SUBJECT: Bank of America at Woodmoor  
Preliminary Plan #1-20060460

SUBJECT: Preliminary Plan No. 120060460  
Bank of America - Woodmoor  
Kensington/Wheaton Policy Area

Re: Montgomery County  
Bank of America/Woodmoor  
Preliminary Plan #1-06046  
MD 193 @ Lexington Drive

RE: Preliminary Plan #1-20060460  
Bank of America-Woodmoor

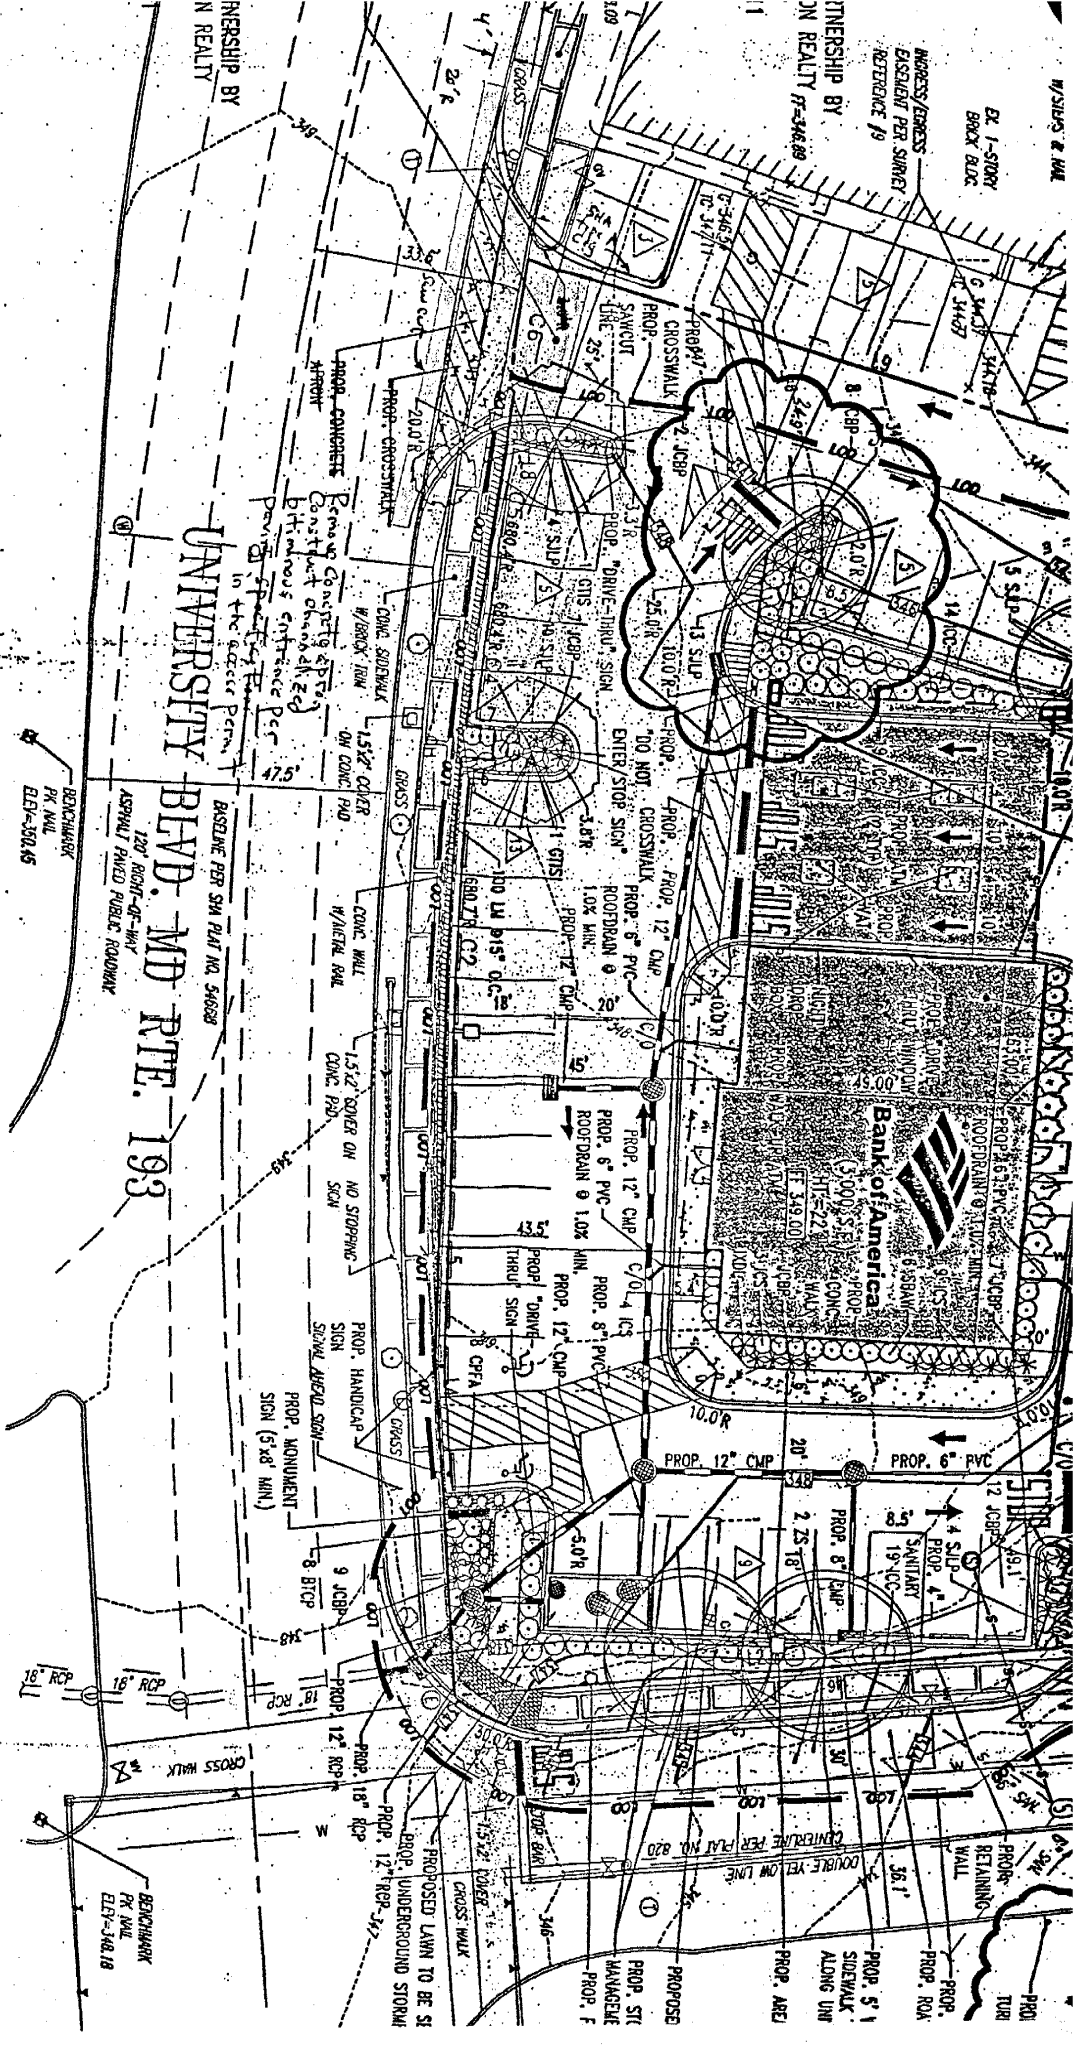
- This revised preliminary plan partially addresses the first comment in our November 18, 2005 letter. This plan shows the reconstruction of the existing MD 193 curb for the inbound portion (east side) of the existing depressed curb entrance. The existing outbound portion of this entrance is shown to remain as is. The applicant must revise this plan to show total reconstruction to a 25' wide with 20' radii commercial entrance. A sketch is attached for guidance.

*We realize that a parking waiver from Montgomery County's Department of Permitting Services may be necessary to accomplish this MD 193 entrance reconstruction. Two or three existing parking spaces will have to be eliminated to properly reconstruct this entrance to meet SHA standards. Please note that close proximity of these few parking spaces with the MD 193 entrance is the primary cause of the operational/safety problems described by comments 1 and 3 in a January 16, 2006 e-mail from Ms. Eileen Emmett. A fully reconstructed MD 193 commercial entrance to SHA's standards should also reduce the frequency of trucks using Lexington Road for access to and egress from the Woodmoor Shopping Center.*
